March 15, 2019

NOTICE OF ADDENDUM ADDENDUM NO. 3

CONTRACT NO. 7528, PROJECT NO. 10305 NAKOOSA TRAIL FLEET/FIRE/RADIO SHOP FACILITY

M-131E

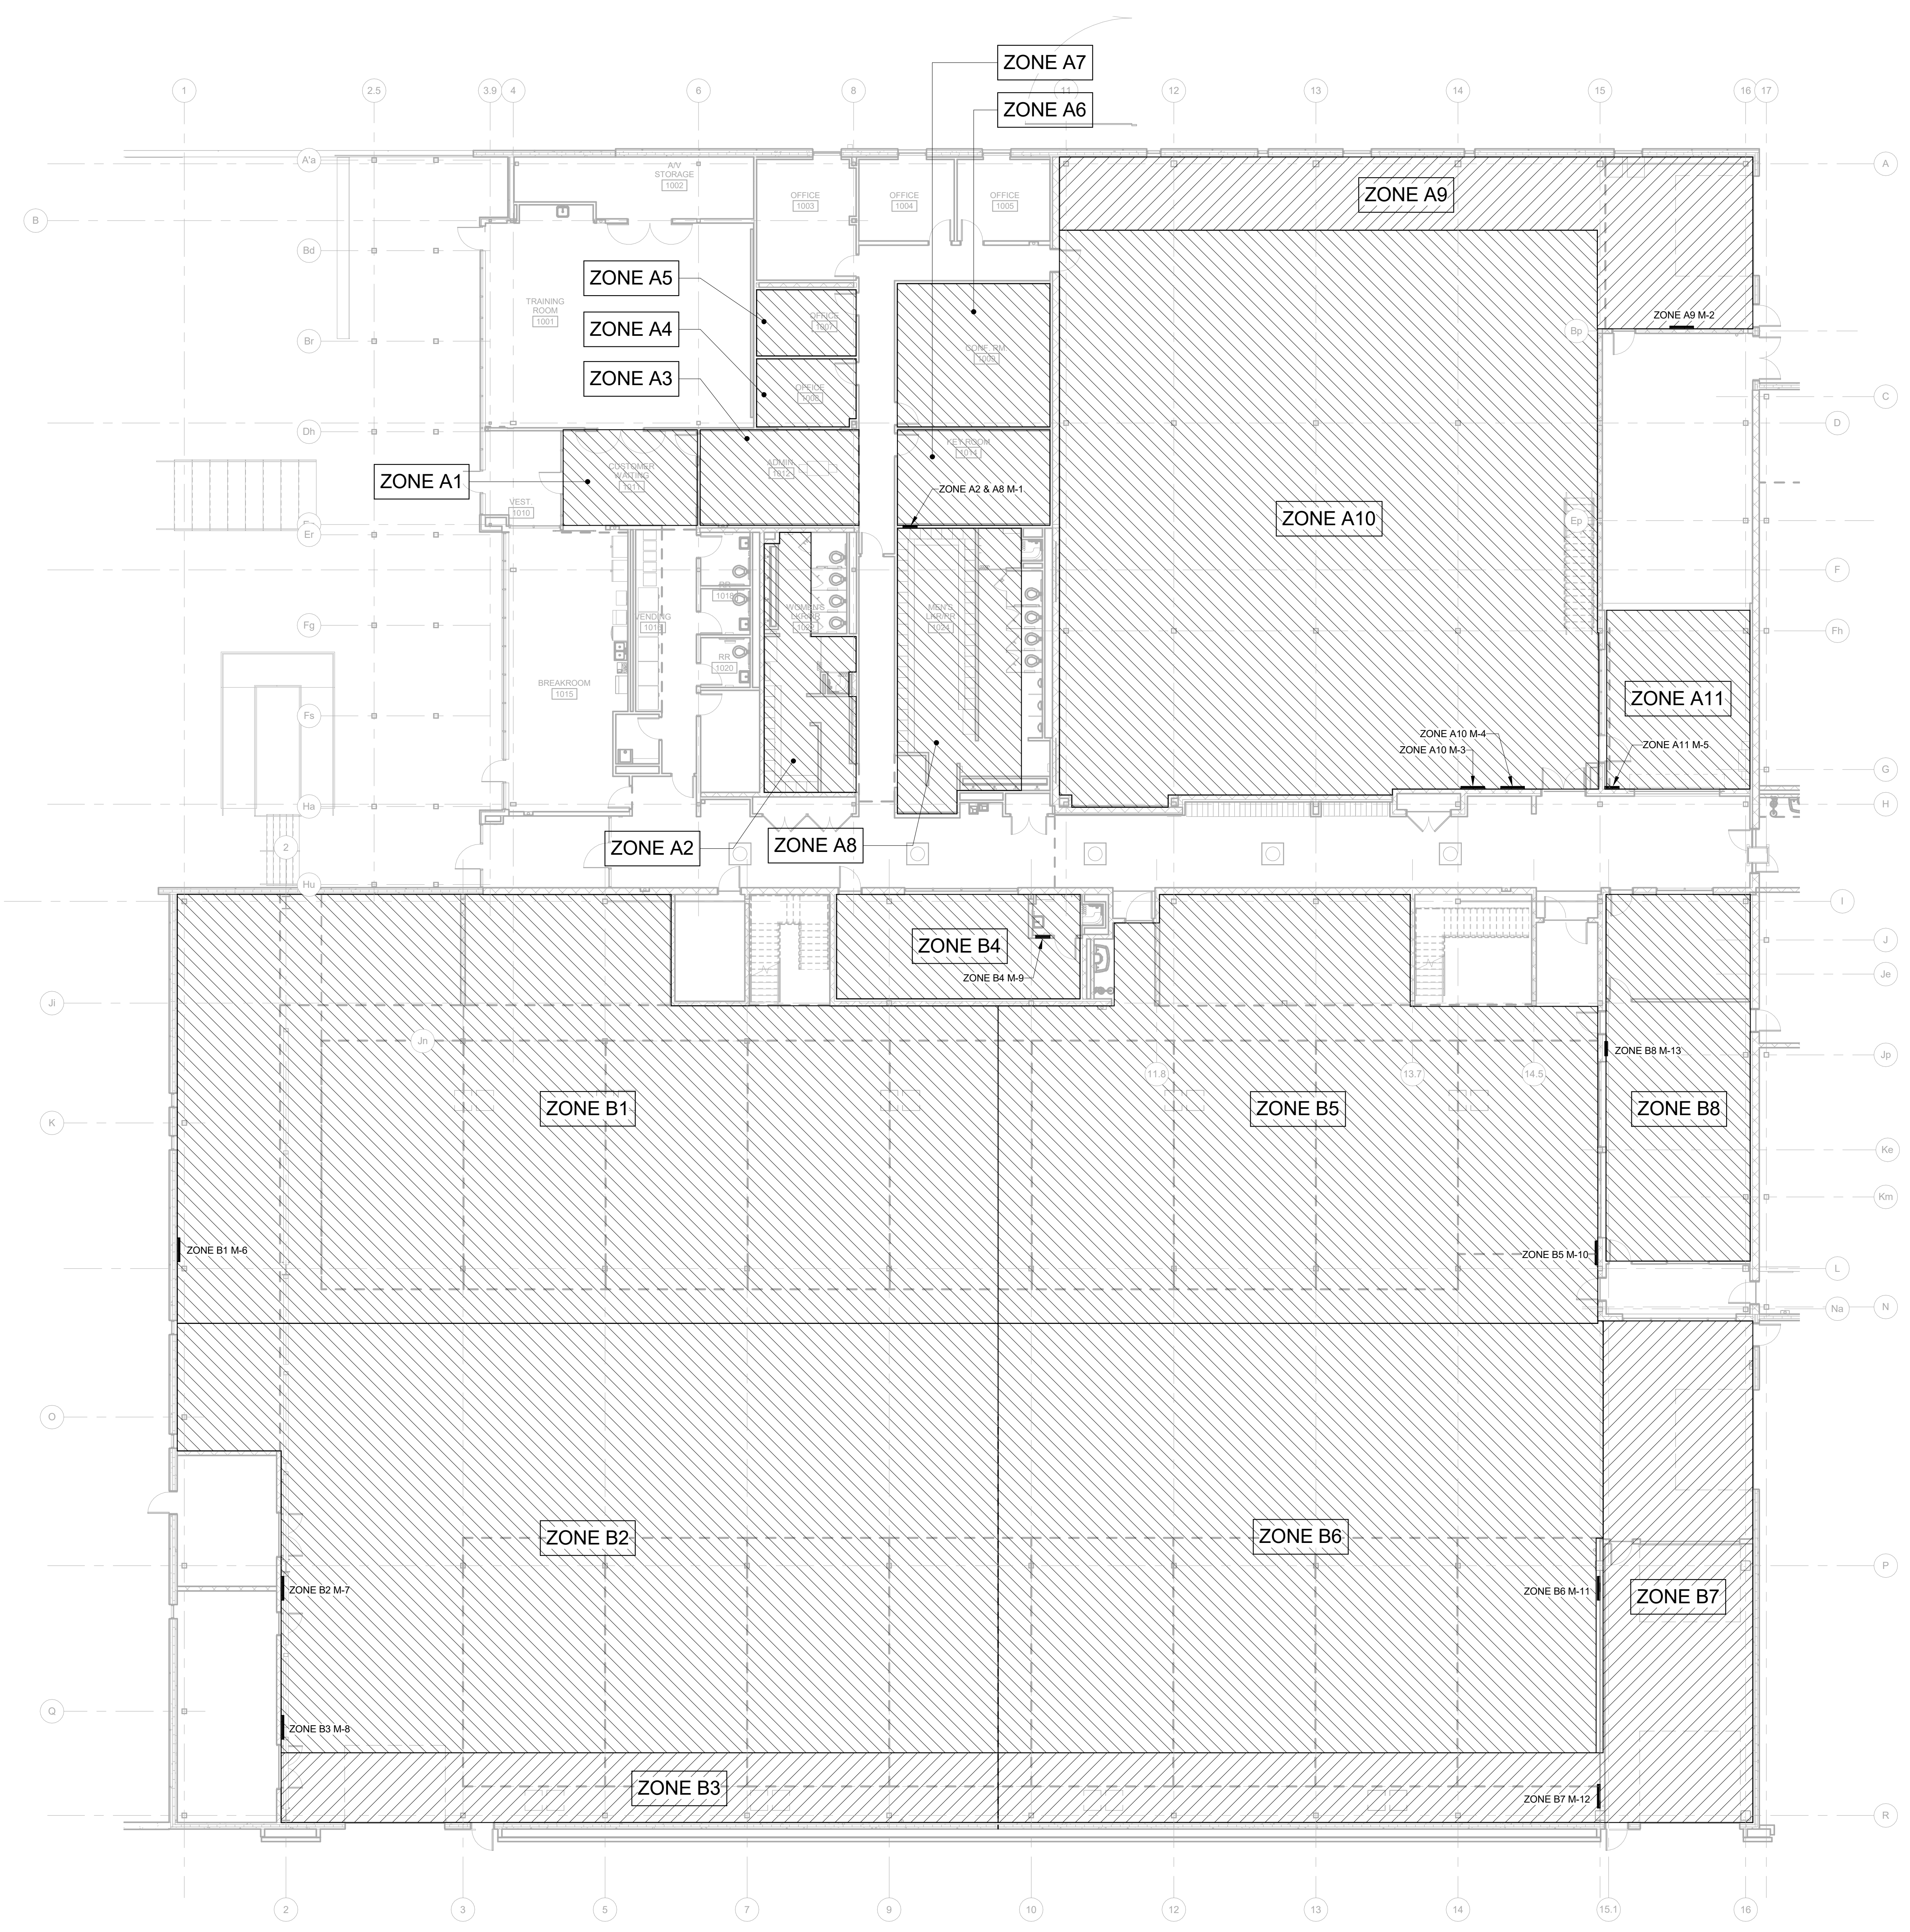
- BBBB. **MODIFIED** S-601 - STRUCTURAL SCHEDULES. See revised drawing attached.
- CCCC. **MODIFIED** M-131E LEVEL 1 FLOOR PLAN – PIPING – AREA E:
 - a. Revise location of Zone E2 M-29 manifold as indicated on sheet M-131E

MECHANICAL WATER FLOW DIAGRAM

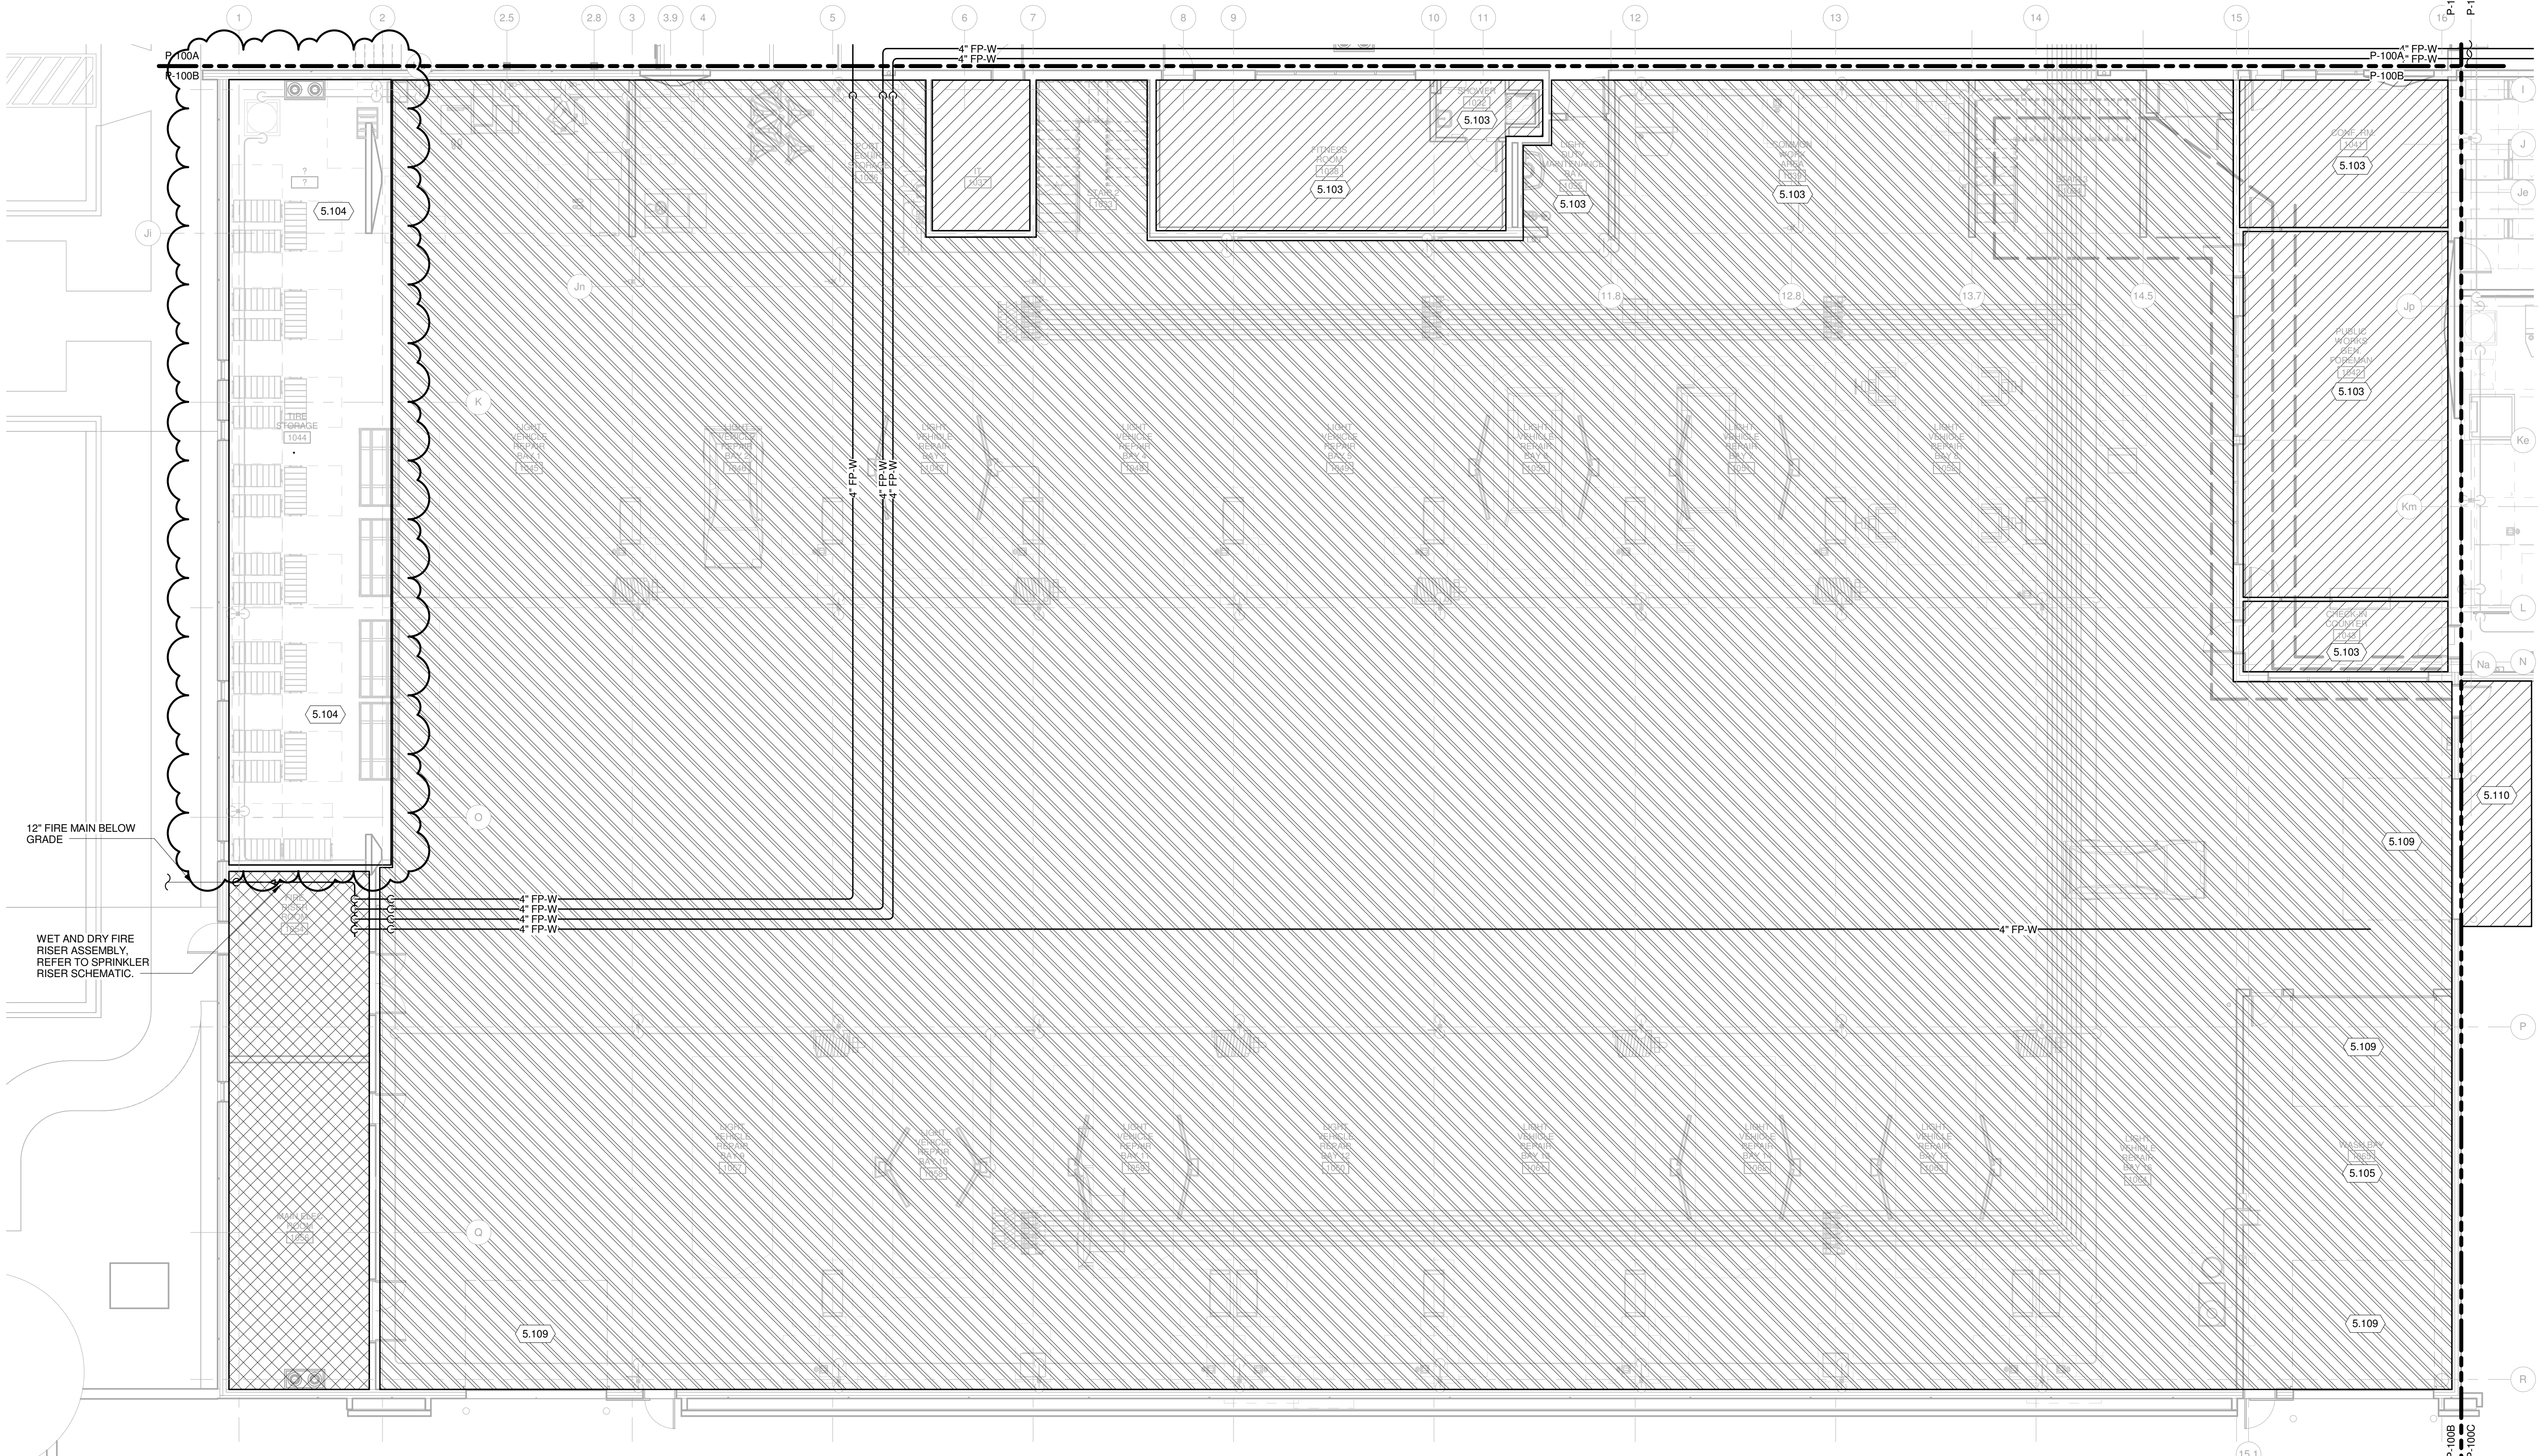
- FFFF. **MODIFIED** M-809 MECHANICAL WATER FLOW DIAGRAM:
 - a. Revised control sequences as indicated on sheet M-809.
- GGGG. **MODIFIED** F-101B LEVEL 1 FLOOR PLAN – FIRE PROTECTION – AREA B:

T-141

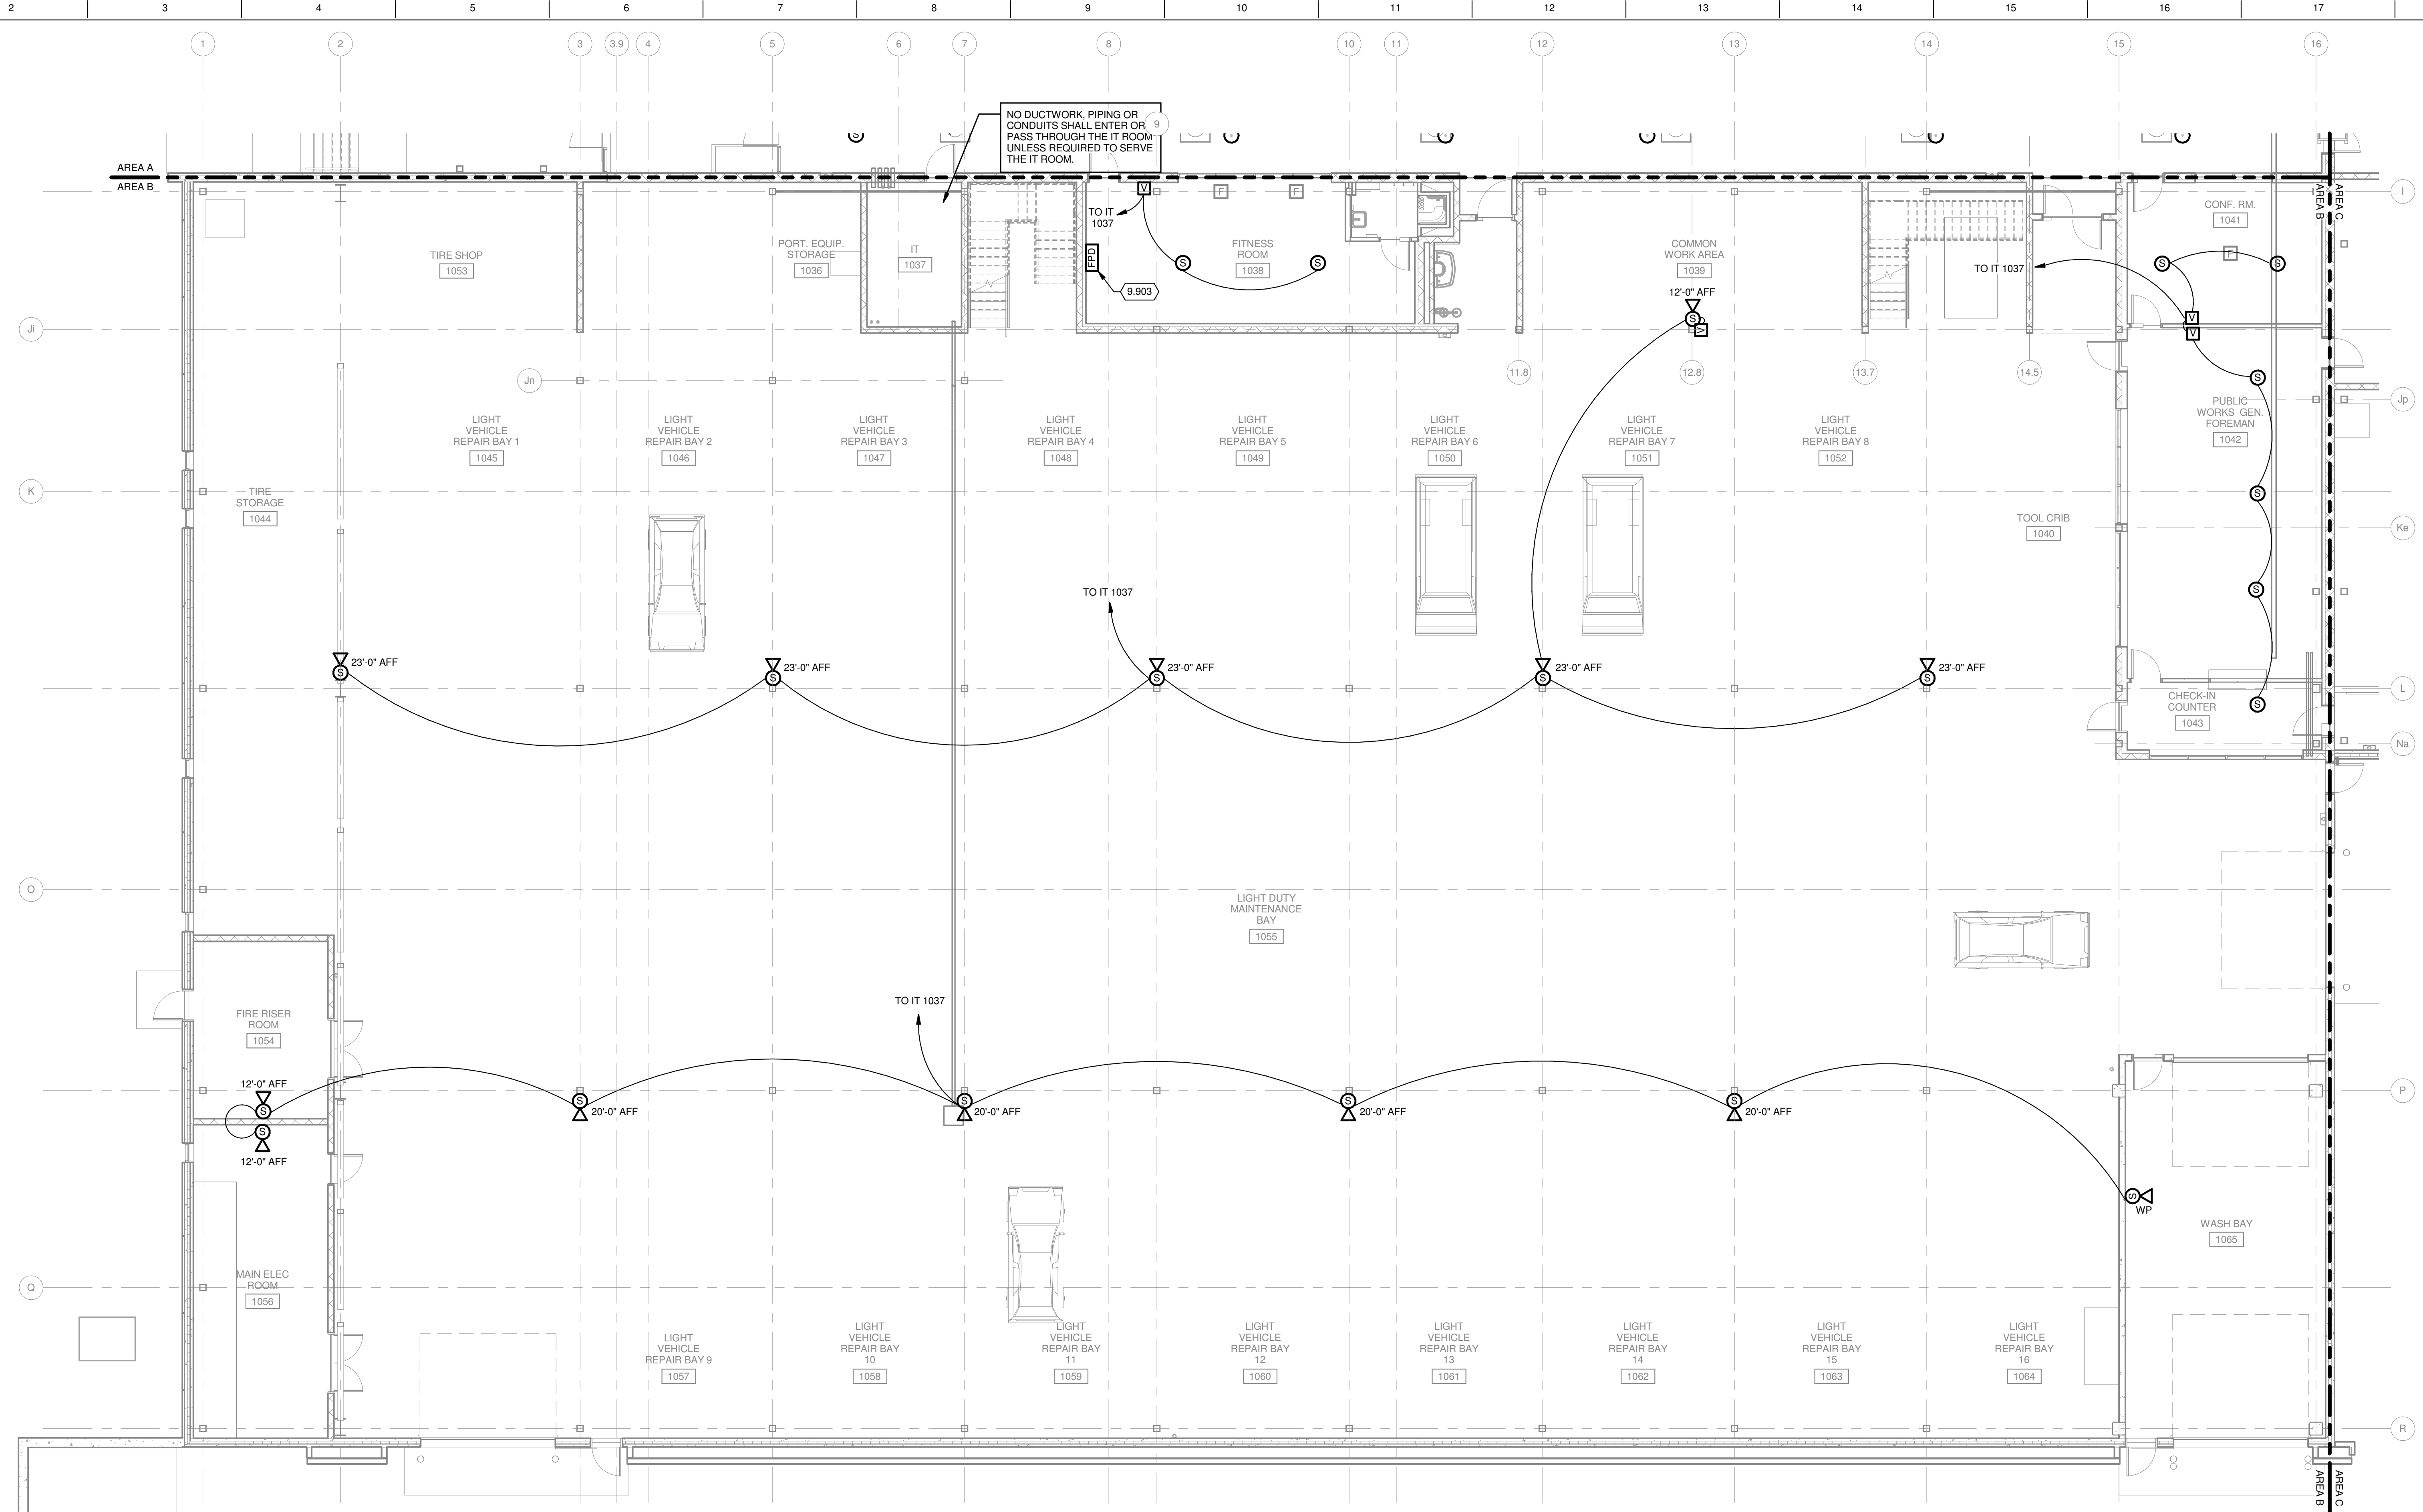
- a. Revise general note #1 to indicate “Sheet E-142” in place of “Sheet E-138”
- LLLL. **MODIFIED** T-141 LEVEL 1 FLOOR PLAN AREA A - AUDIO/VISUAL
 - a. Revise general note #1
